**Spartanburg Community College
Cherokee Campus Whelchel Road Entranceway
Project No. H59-N153-MJ**

**Addendum Two
September 28, 2023**

CV2.1

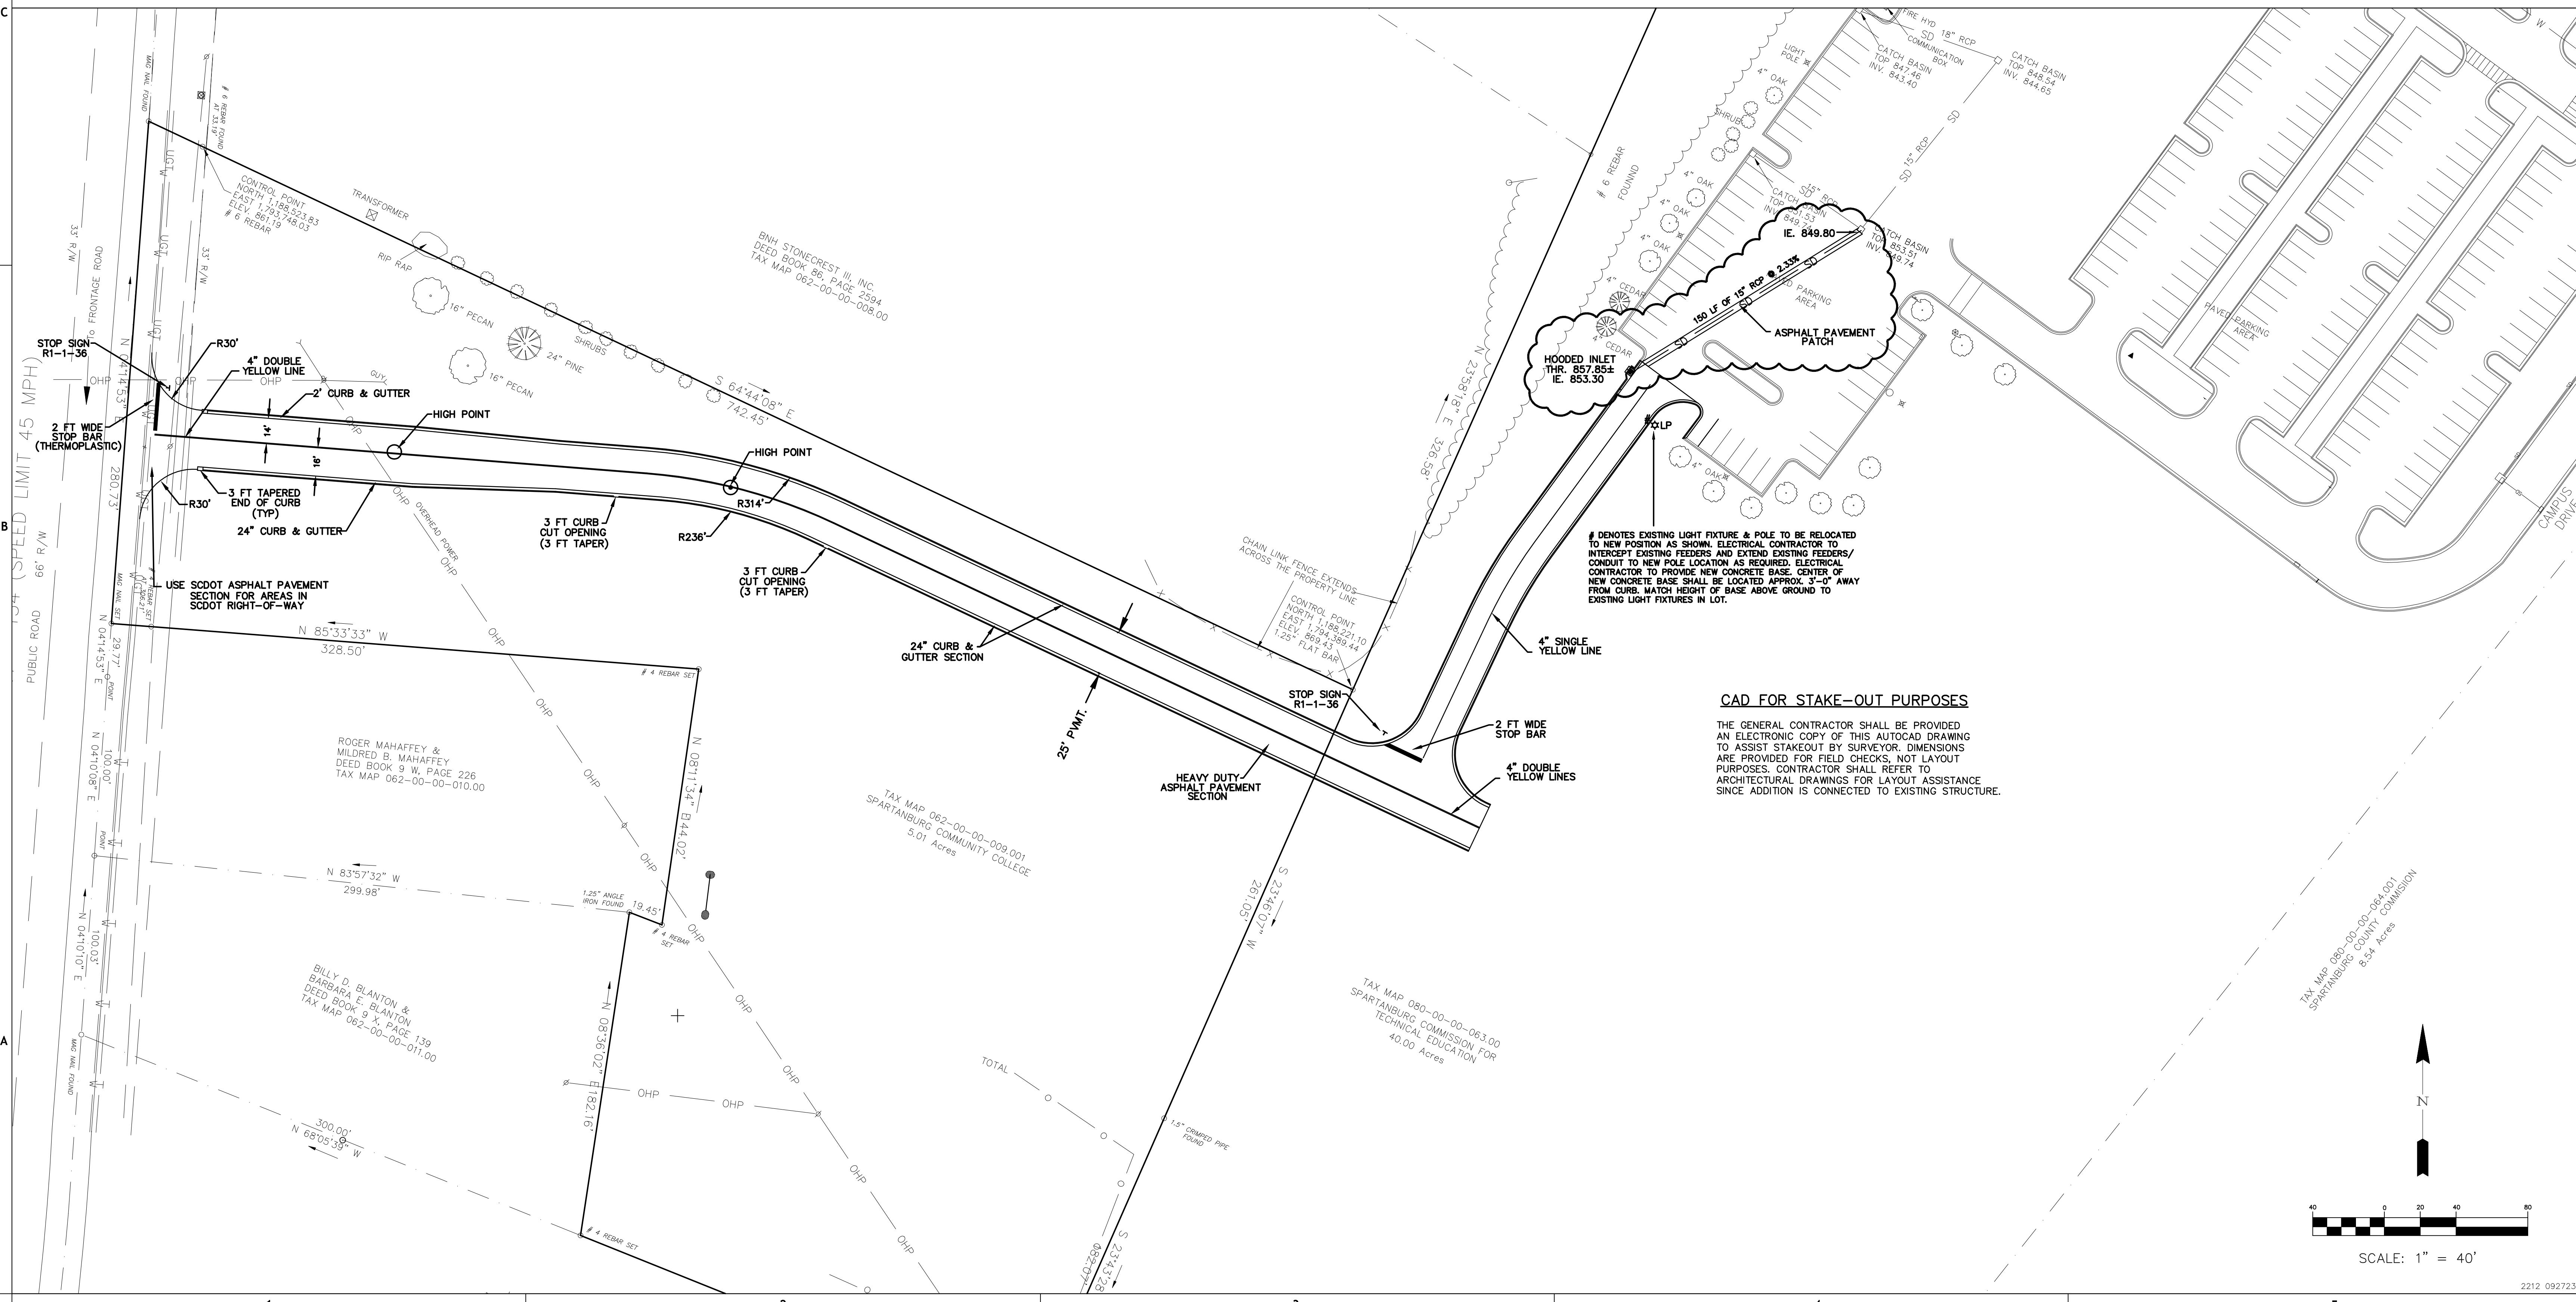
Item No. 1: The new catch basin near the drive connection to the existing CAMIT parking lot is a hooded agree inlet (Detail 4.1L) with a throat elevation of 857.85 and invert elevation of 853.30. The storm drain pipe is 150 LF of 15" RCP laid at 2.33%, and connects to the existing grate inlet basin in the CAMIT parking lot. These items are part of the project scope. See revised CV2.1 (attached).
